STAFF REPORT SUMMARY

To: Edgerton Planning Commission
Fr: Kenneth Cook, AICP, CFM, Community Development Director
Re: PS2017-02, Preliminary Site Plan for LPKC Lot 3 – Inland Port VI, located on the South side of 183rd Street and East of Montrose.

STAFF REPORT

To: Edgerton Planning Commission
Fr: Kenneth Cook, AICP, CFM, Community Development Director
Re: Application PS-2017-02 for Preliminary Site Plan for Logistics Park Kansas City, Inland Port VI, located at the southeast corner of 183rd Street and Montrose Road.

1 OVERALL EAST ELEVATION
Scale: 1:50

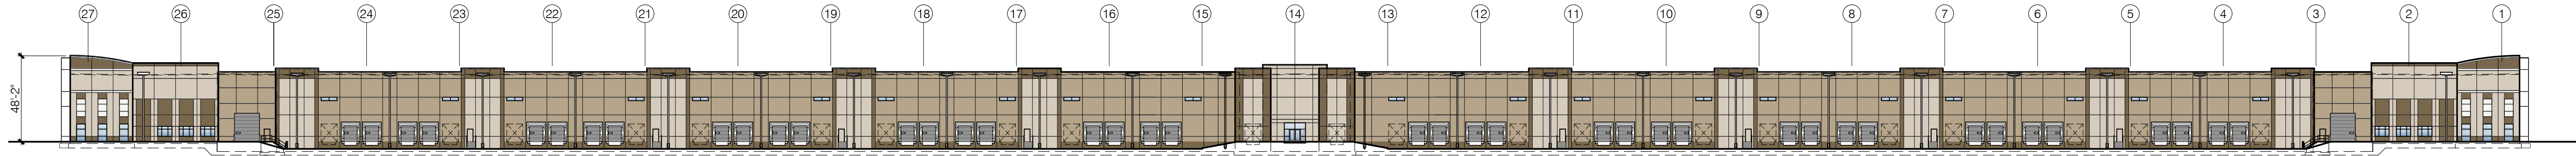
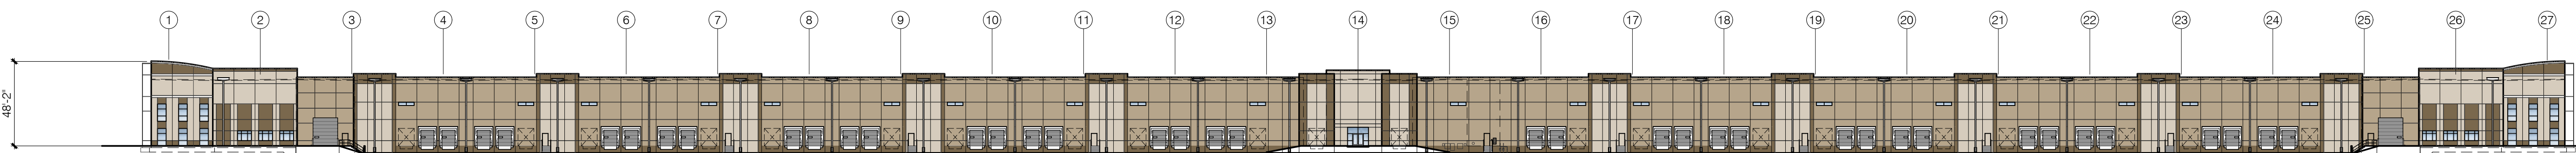
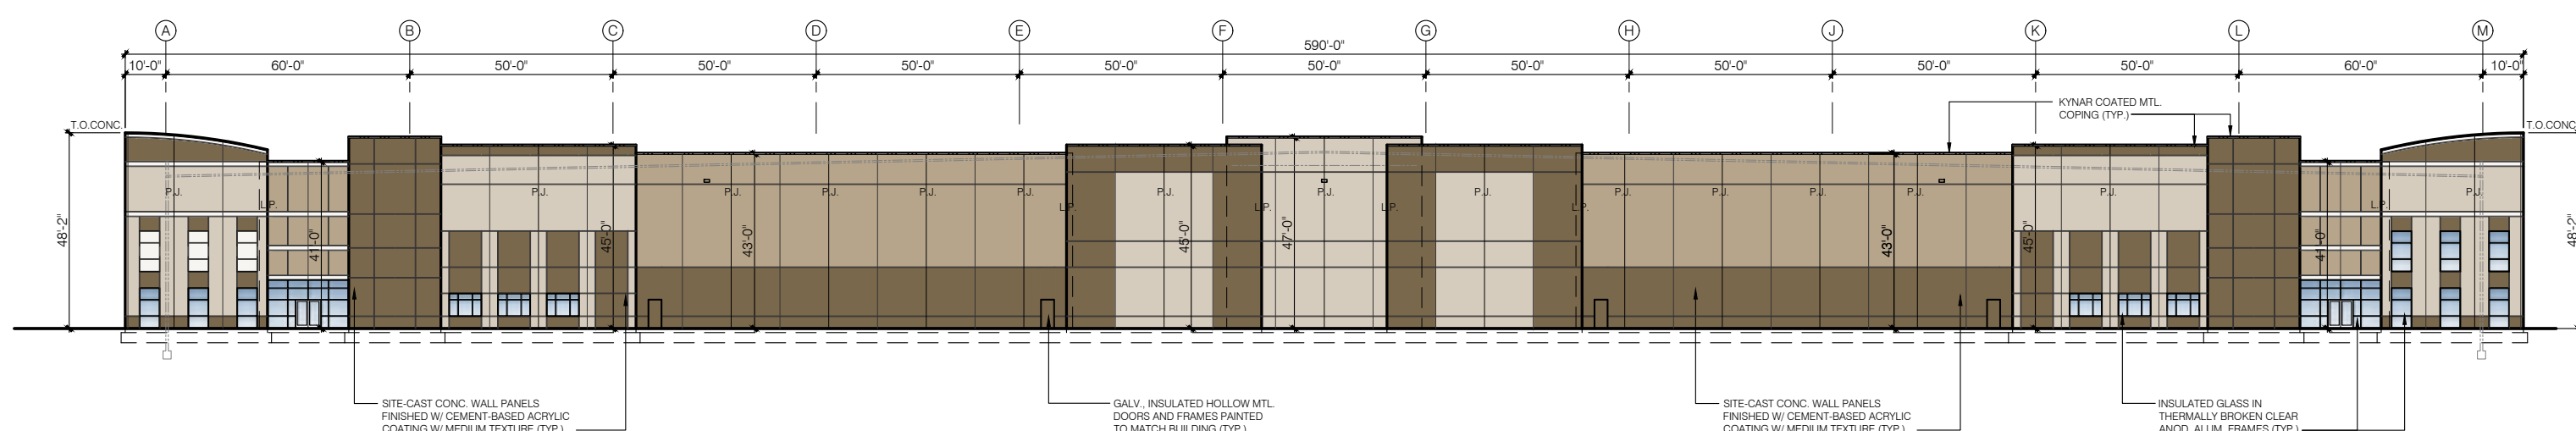
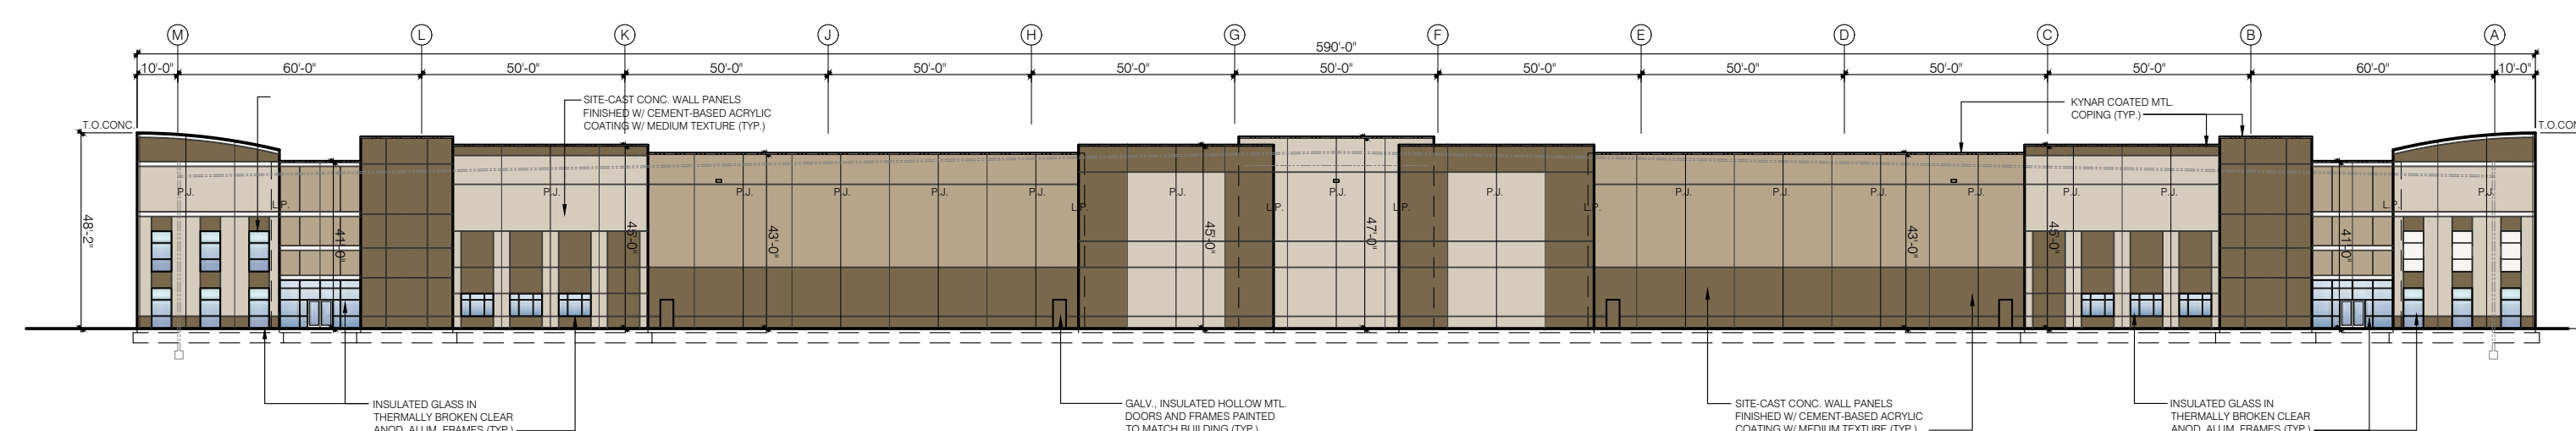
5. Sheet #5
- a) Scale drawings of all building elevations. *Architectural elevations have been submitted. Will need to be submitted with Final Site Plan.*

- b) Roof pitch and materials. *Will be submitted with Final Site Plan.*
 - c) Siding type and materials, including fascia. *Site cast concrete wall panels finished with cement-based acrylic coating with medium texture. Colors are coordinated with previous buildings. Same information will be submitted with Final Site Plan.*

- d. Rear. The minimum rear yard adjacent to a residential use is 50 feet. ***In this instance rear is south. Preliminary Site Plan complies.***
2. Maximum Building Height. The maximum height allowed is 110 feet. ***Building elevations submitted indicate a building height of 48'2". Preliminary Site Plan complies.***

Building elevations submitted meet these requirements by utilizing features specified in a, b, c and d. There is limited use of letter e.

*Like the horizontal articulation requirement, walls not facing a public right-of-way or a residentially zoned property are exempt from this requirement. In this instance, the eastern wall faces single-family residential uses and zoning and the western wall faces public ROW (Montrose Street). The north faces 183rd Street. The south wall faces undeveloped property that is zoned county Rural, but is part of the current request to rezoned to L-P District. Walls with loading dock doors must still meet this standard. Full dimensions have only been provided for the North and South elevations and so the compliance of the East and West walls are not able to be determined. The minimum height change required is between 4.1 & 4.8 feet. The maximum change in height shown on the south elevation (across the entire length of the building) is 6'-10" feet (41'-0" to 48'-2"). While the articulation between the tops of the lowest and tallest walls exceed this requirement, the overall articulation does not comply as the 10% change in height is required to occur within each 192.6 foot section of wall. While the elevations do not comply with this requirement more, smaller articulations are provided. The vertical articulation being provided appears to be the same as that shown on previous projects. **The elevation plans do not comply with this requirement. The Planning Commission may decide to approve an exceptions to this requirement based upon the façade elevations that have been provided.***

- c. Screening of Rooftop Equipment. For buildings within the L-P District, all rooftop mounted mechanical, air conditioning, electrical, and satellite dish equipment shall not be visible. Rooftop equipment shall be screened from ground and street level view with parapets or other architectural design features constructed of the same materials used on the exterior walls. ***Building elevations submitted do not depict roof top equipment.***

A1.06
OVERALL FLOOR PLAN

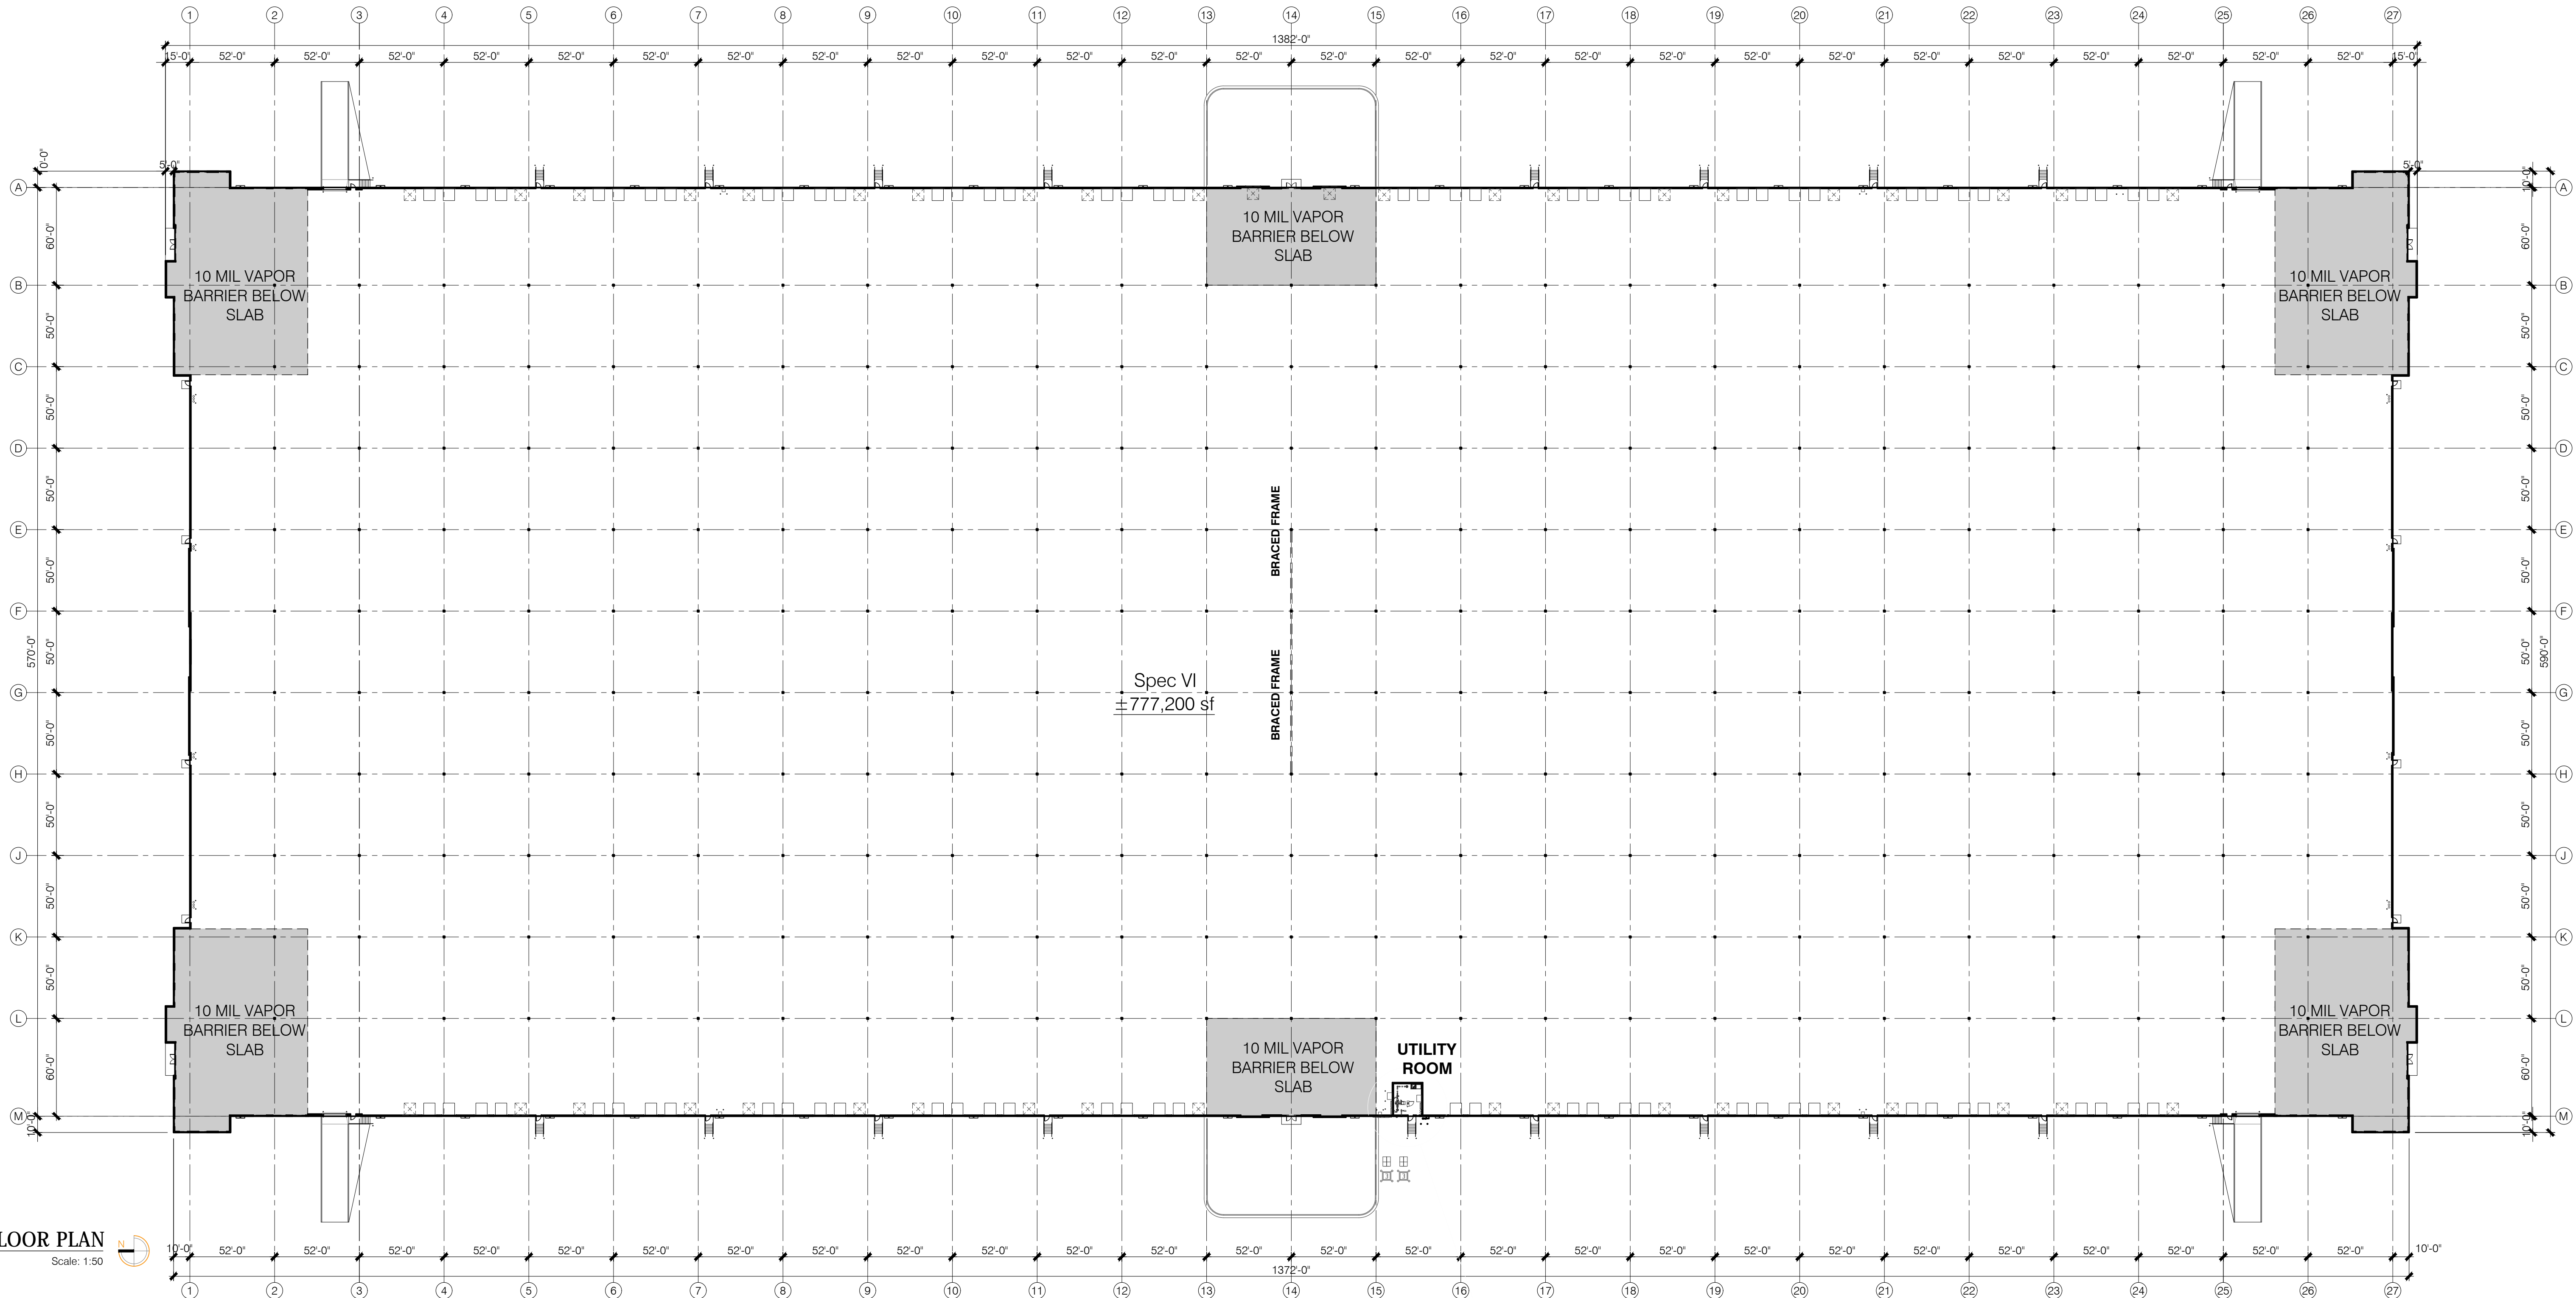
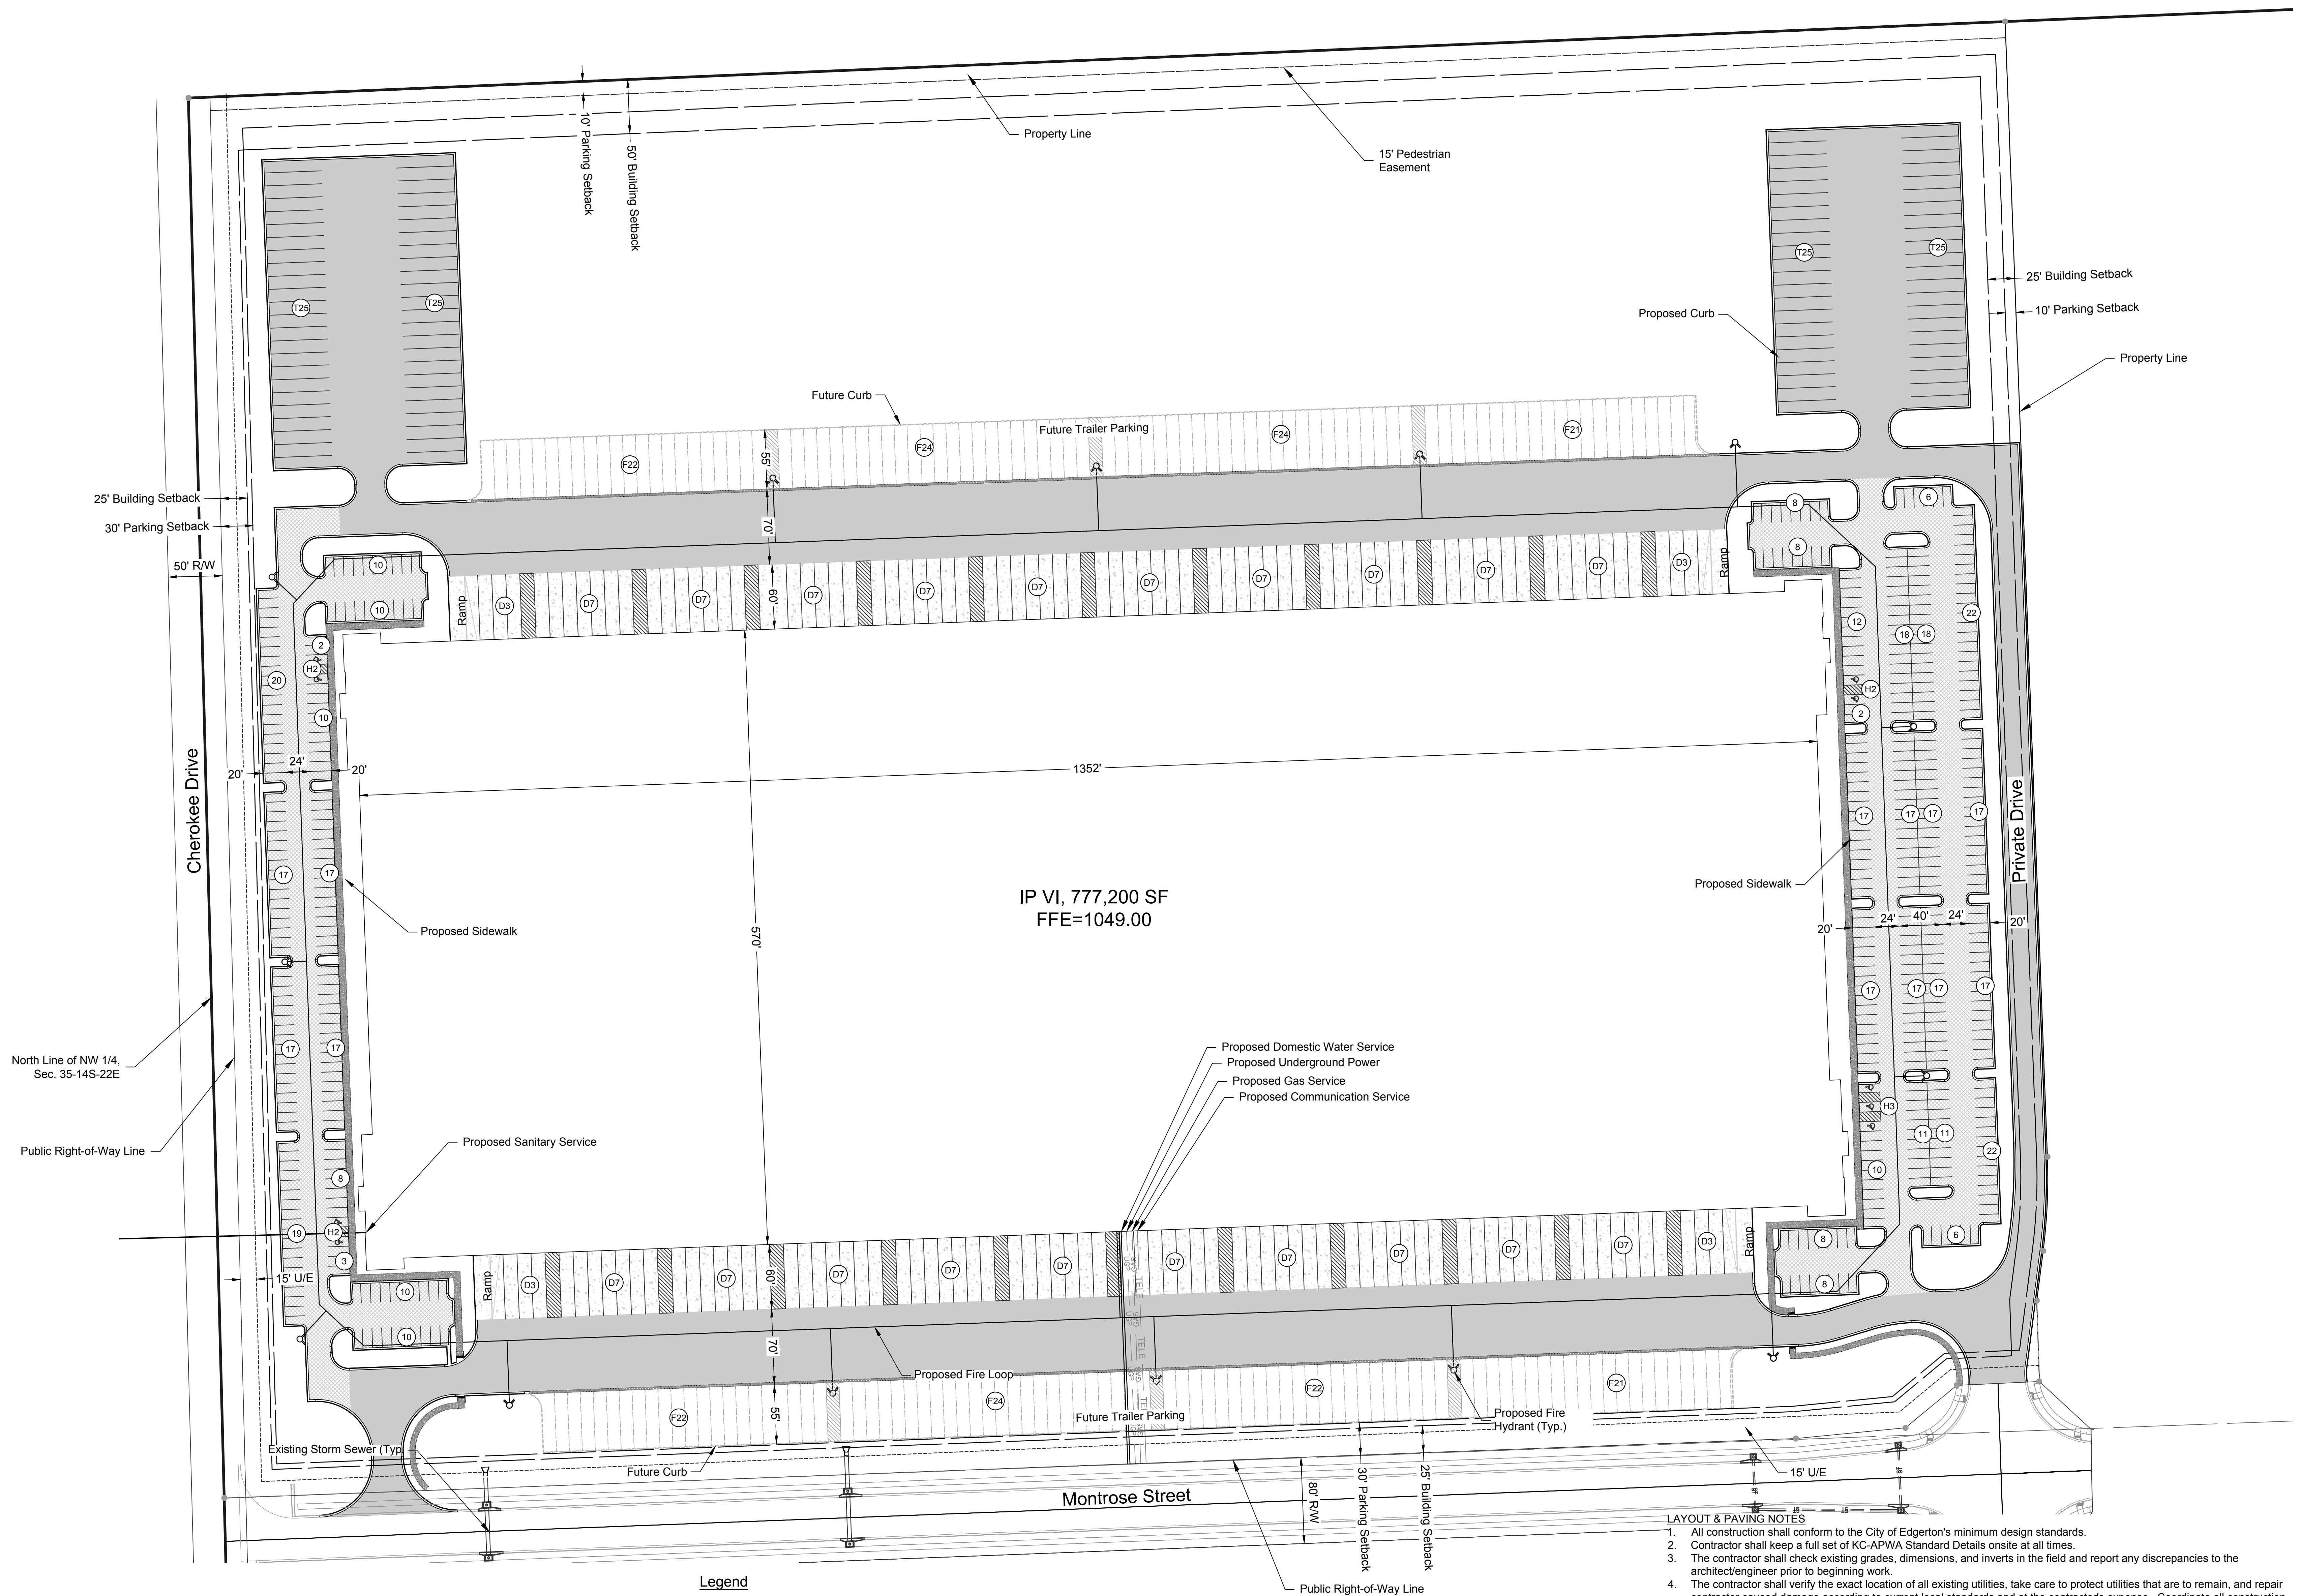
- a) Scale drawing of building floor plans. *Staff understands that the proposed building is speculative and no final interior plans have been created. An Architectural sheet depicting the building's overall floor plan and elevations has been submitted.*

- b) Dimensions and use of rooms and areas. *Will be reviewed at Building Permit Review.*
 - c) Dimensions of entrances/exits and corridors. *Will be reviewed at Building Permit Review.*
